REMARKS

Appl. No. 09/127,571
Amtd. Dated Jan. 26, 2004
Reply to Office Action of Oct. 24, 2003
Annotated Sheet Showing Changes

FIG. 7

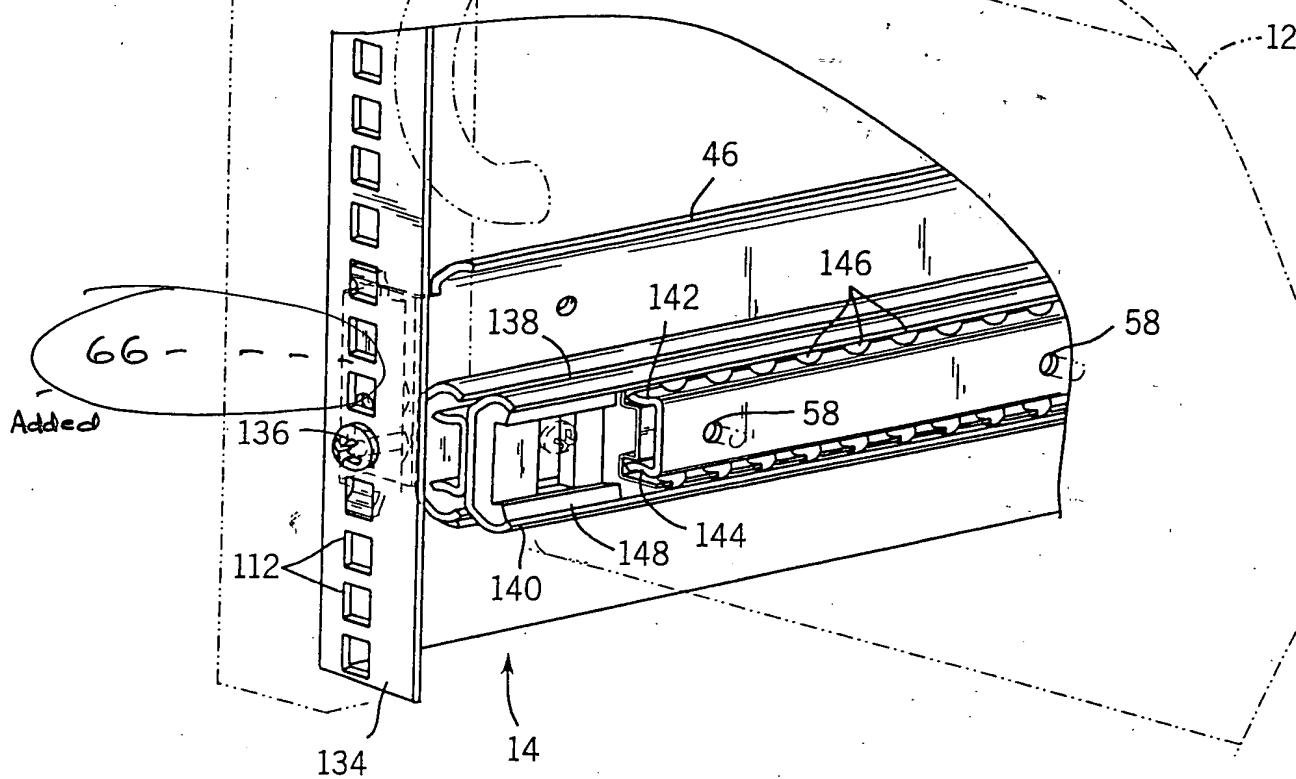
In the Office Action, the Examiner objected to the illustration of the lead line of reference number 66 in Fig. 7 having a solid form, thus failing to indicate the hidden nature of the element to which it refers. Although Applicants believed that corrections to the drawings were provided in a previous response, the Examiner indicated that no drawing amendments were received with the previous response. Accordingly, Applicants resubmit the amendments to drawings. Specifically, Applicants submit an amended page illustrating the amendments to the figures in red ink. Additionally, Applicants also provide a replacement page incorporating the amendments to the drawings. With the foregoing in mind, Applicants respectfully request that the Examiner withdraw the objection to the drawings.
